# Newage Garments Ltd. (Extension)

4 December 2024

## 2. Observation

### Column layout plan

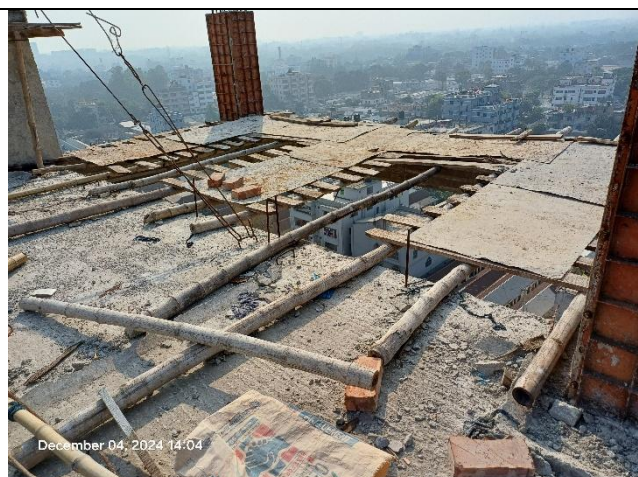
**Description:** The cursory calculation indicated that the columns are stressed above the normal design limit considering the prepared live load plan and minimum concrete strength based on aggregate type as the frequency of testing is not met in compliance with BNBC 5.12.1.

Building engineer is required to review the design load and column stress based on the insitu material strength.

Also, building engineer is required to review the design load and MAT stress based on the insitu material strength.

| Item No. | Observation                                                                                   | Action Plan                                                                                                                                                            | Timeline        |
|----------|-----------------------------------------------------------------------------------------------|------------------------------------------------------------------------------------------------------------------------------------------------------------------------|-----------------|
| 1.       | Stress in the column & foundation exceeds the normal design limit (Production Building-03)    | Verify in-situ concrete strength by taking a 100-diameter concrete core from the lower-tier columns.                                                                   | Immediate       |
| 2.       |                                                                                               | The building engineer is required to review the design, load and column and foundation adequacy check as per the in-situ material strength.                            | within 6 weeks  |

**Storage on the ground floor**

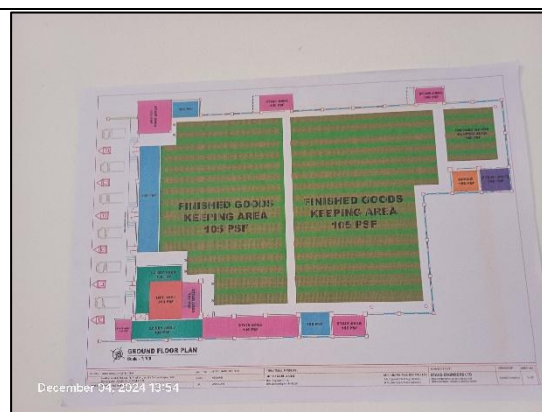
**Description:** The suspended ground floor of the production building-03 is allotted for storage. As per BNBC, the minimum floor live load for storage is 6 kN/m<sup>2</sup> (126 psf). However, the ground floor of the building is designed for 5 kN/m<sup>2</sup> live loads. The building engineer is required to revise the load plan and related design documents based on BNBC requirements.

| Item No. | Observation                                                                                   | Action Plan                                                                                                                                                            | Timeline        |
|----------|-----------------------------------------------------------------------------------------------|------------------------------------------------------------------------------------------------------------------------------------------------------------------------|-----------------|
| 6.       | The load plan does not comply with BNBC requirements. (Production Building -03)               | The building engineer is required to revise the load plan based on BNBC requirements.                                                                                  | within 6 weeks  |

Truss in North-South direction

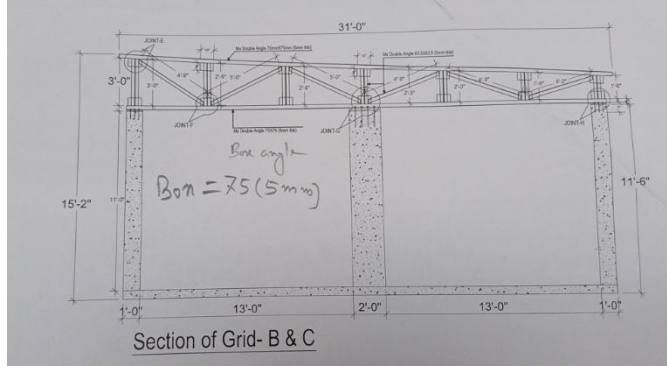
**Description:** Lack of lateral stability system (bracing & strut) at roof level was found along the long direction. So, lateral stability in the long direction is incomplete. The building engineer is required to check the stability system of the existing structure, prepare an assessment report and submit it to RSC for review.

| Item No. | Observation                                                                                   | Action Plan                                                                                                                                                            | Timeline        |
|----------|-----------------------------------------------------------------------------------------------|------------------------------------------------------------------------------------------------------------------------------------------------------------------------|-----------------|
| 11.      | Lack of lateral stability system (Ancillary Building - 01 (Captive Generator & EGB Building)) | The building engineer is required to check the stability system of the existing structure, prepare an assessment report and submit it to RSC for review.               | within 6 weeks  |

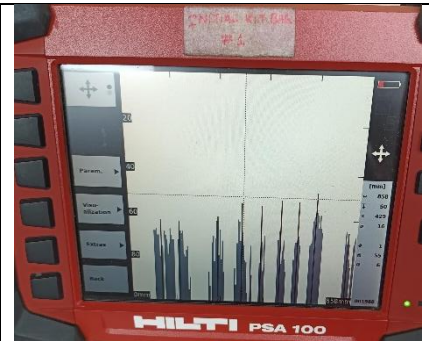
**Description:** Rebar at C-3 type column not matched with drawings. The number of rebar found 20 instead of 24. Building engineer is required to confirm the amount of rebar in the column and update the drawing.

| 13. | Mismatches in as-built drawings (Ancillary Building-02 (Fire Control Room & Office The building )).                             | The building engineer is required to confirm the amount of rebar in the column and update the drawings.                   | within 6 weeks  |

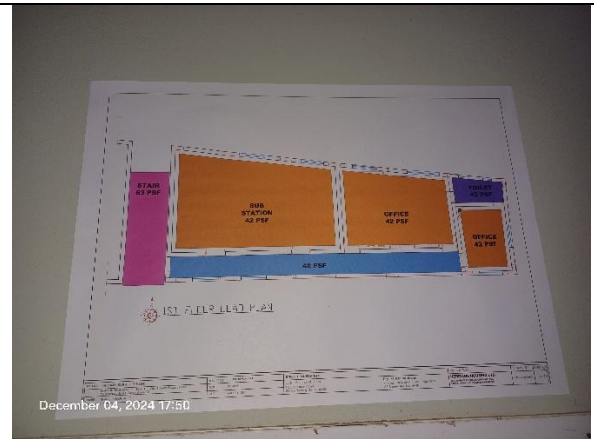
**Description:** There is a steel staircase between Ancillary Building-01 and Ancillary Building-02. As per BNBC, the minimum floor live load for stairs is 4.8 kN/m<sup>2</sup> (100 psf). But the stair is designed for 3 kN/m<sup>2</sup> (63 psf) live loads.

The building engineer is required to revise the load plan and related design documents based on BNBC requirements.

| 14. | Load plan does not comply with BNBC requirements (Stair Portion) (Ancillary Building-02 (Fire Control Room & Office Building)). | The building engineer is required to revise the load plan and related design documents based on BNBC requirements.        | within 6 weeks  |

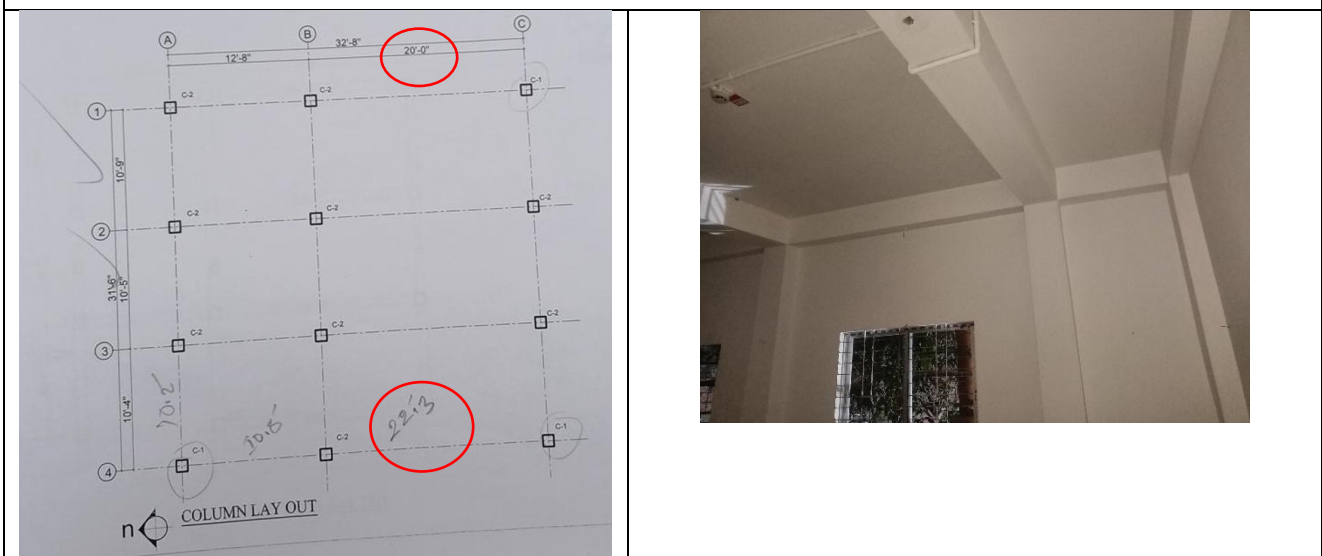
**Description:** The C1 column was found to be 300mmx300mm (12X12 inches) instead of 350mmx350mm and the down stand of the beam was 300 mm instead of 450 mm. Also, one grid was measured at 6.7m (22 feet), whereas the drawing shows 6.1 m (20 feet). The building engineer is required to survey the structure and update the as-built drawing as per onsite conditions.

| 16. | Mismatches in as-built drawings (Ancillary Building-03 (Diesel Generator & Compressor The building )).                          | The building engineer is required to survey the full structure and revise the as-built drawing as per on-site conditions. | within 6 weeks  |

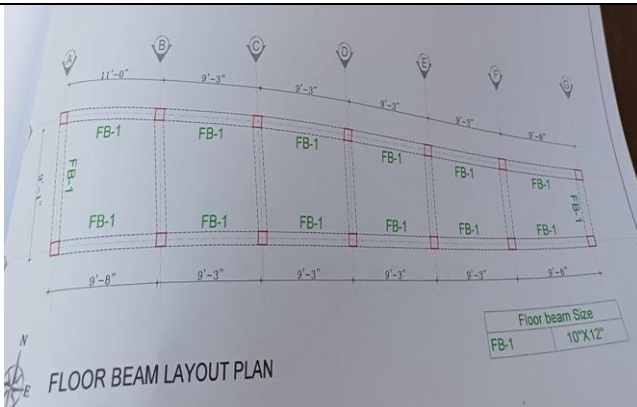
**Description:** No RC column was found in Compressor Room-01 (NGL Compressor Room). But as built drawings showed RC columns. The building engineer is required to confirm the presence of RC columns and update the drawing.

| 20. | Mismatches in as-built drawings (Compressor Room-01 (NGL Compressor Room))                                                      | The building engineer is required to confirm the presence of RC columns and update the drawing.                           | within 6 weeks  |

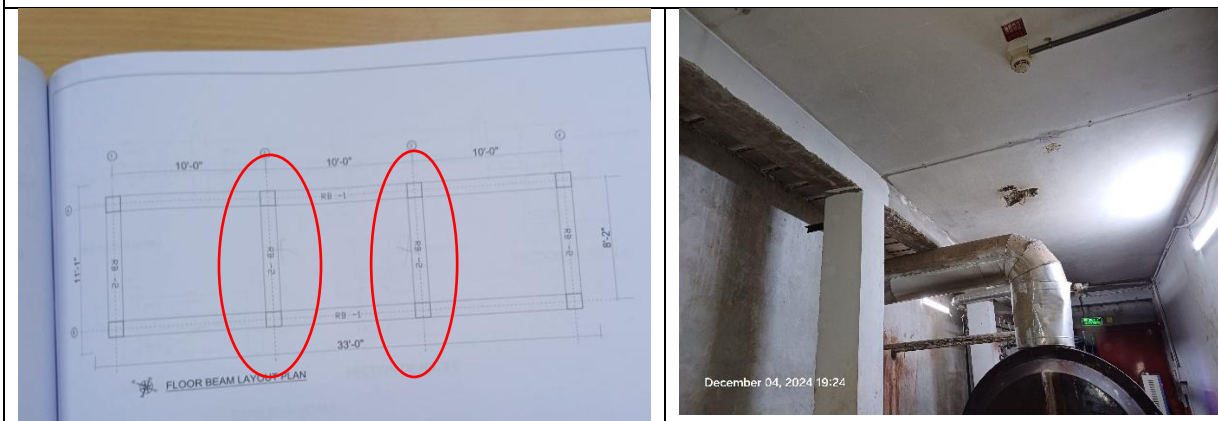
**Description:** Rebar at C-2 type column not matched with drawings. Three rebars were found at the short face and the column size was found 12" (300 mm) instead of 15"(375 mm). The building engineer is required to confirm the amount of rebar & the size of the column and update the drawing.

| 22. | Mismatches in as-built drawings (ATM Booth)                                                                                     | The building engineer is required to confirm the amount of rebar & the size of the column and update the drawing.         | within 6 weeks  |
